From: Paul G. Shumejko, MBA, M.S., P.E., PTOE, Transportation Engineering Manager
To: Kristen Kapelanski, AICP, Manager of Planning
Date: May 31, 2019
Re: Cumberland Village, City File #17-019, Section 27
Livernois Rd Access Options

FoxBoro Subdivision
Section 8

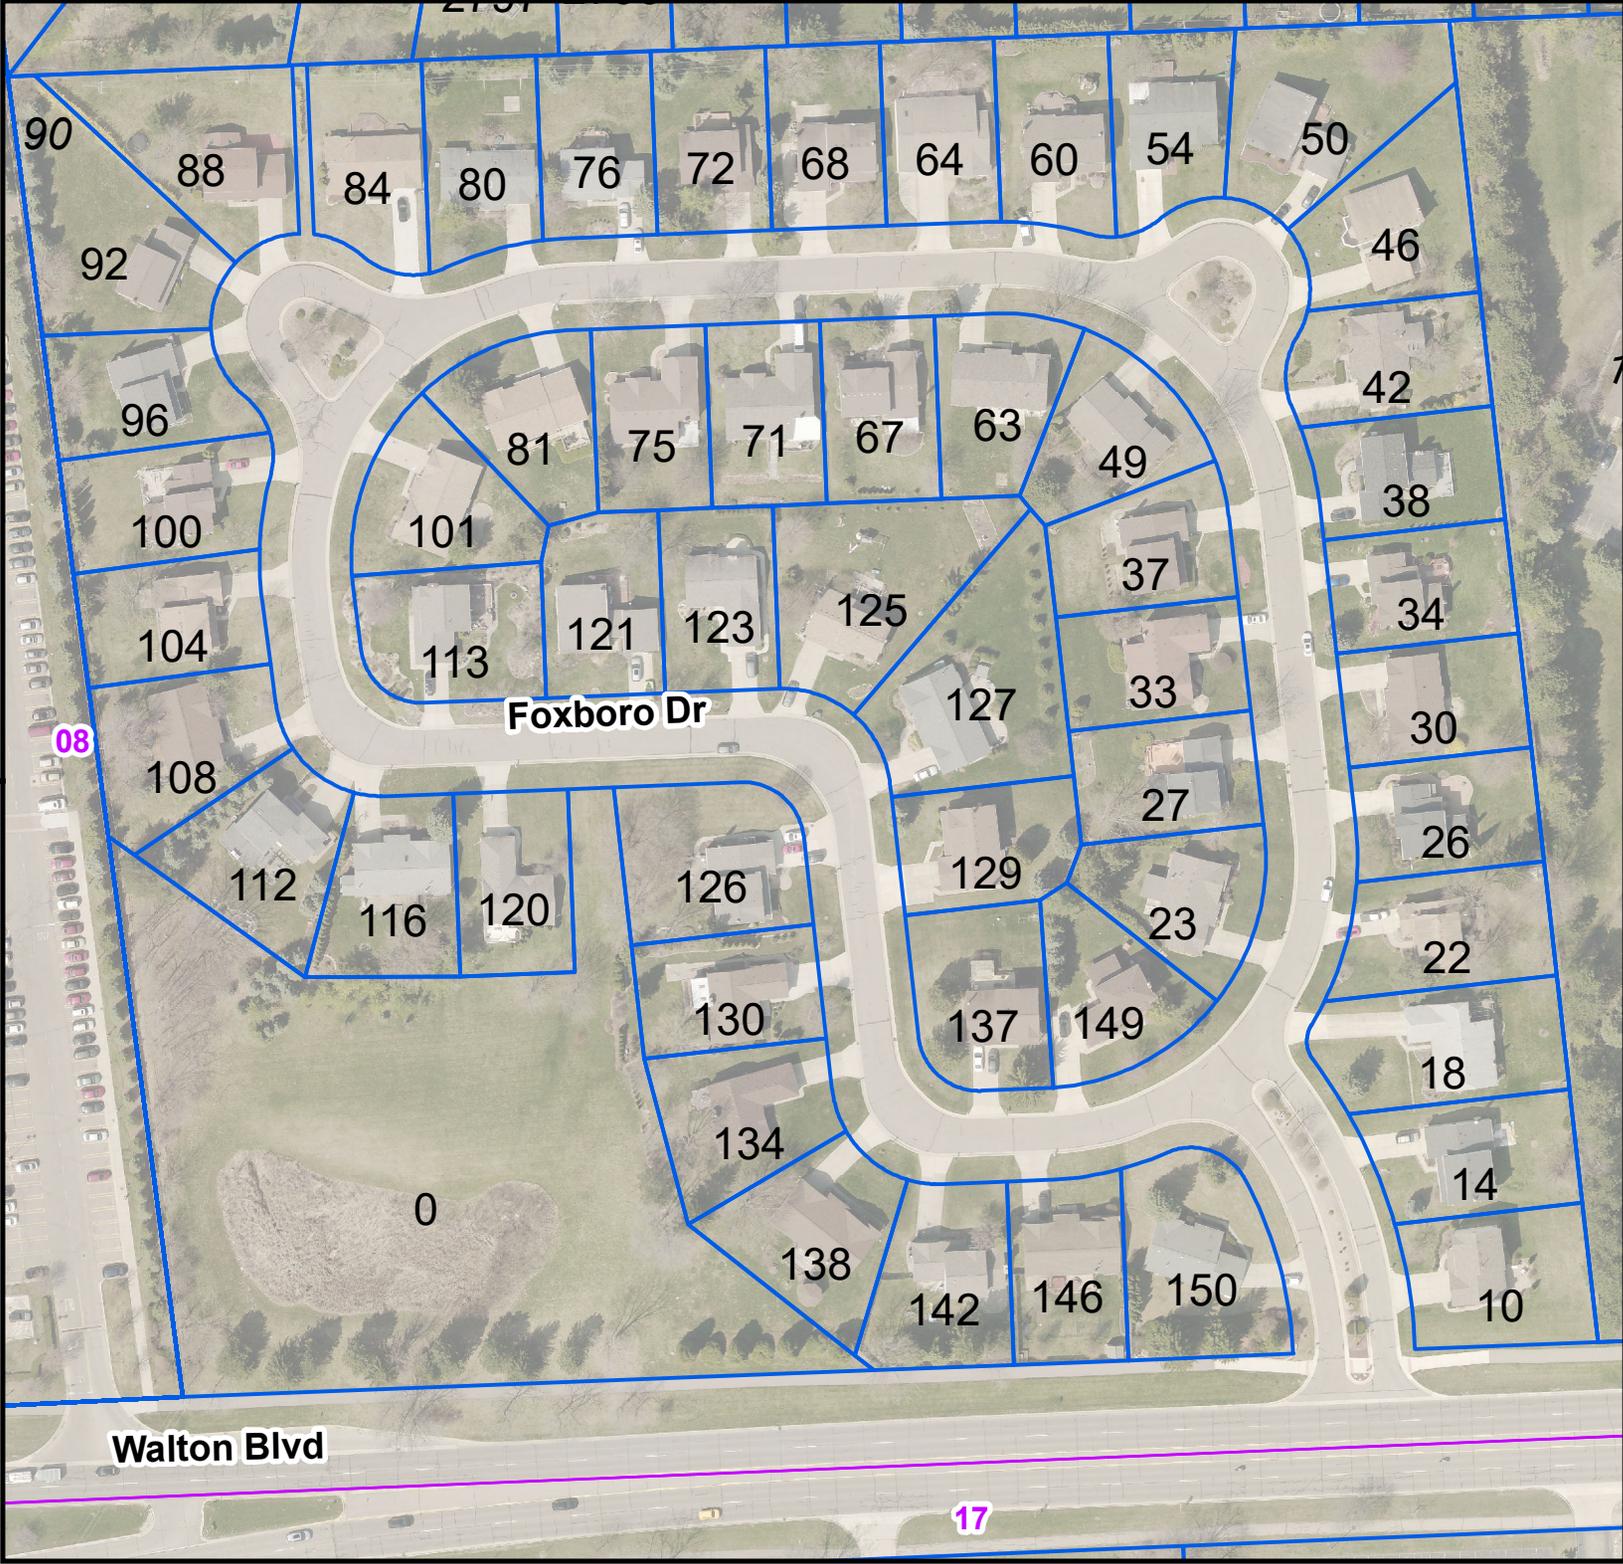
- The secondary access for this site is not required from a traffic engineering perspective.
- For comparison purposes, Foxboro subdivision, located off Walton Blvd in CITY section 8, is an existing similar sized subdivision with a boulevard entrance that has never experienced internal traffic related issues. Foxboro has 54 existing homes compared to the 57 proposed with the Cumberland Village site (see attached map).
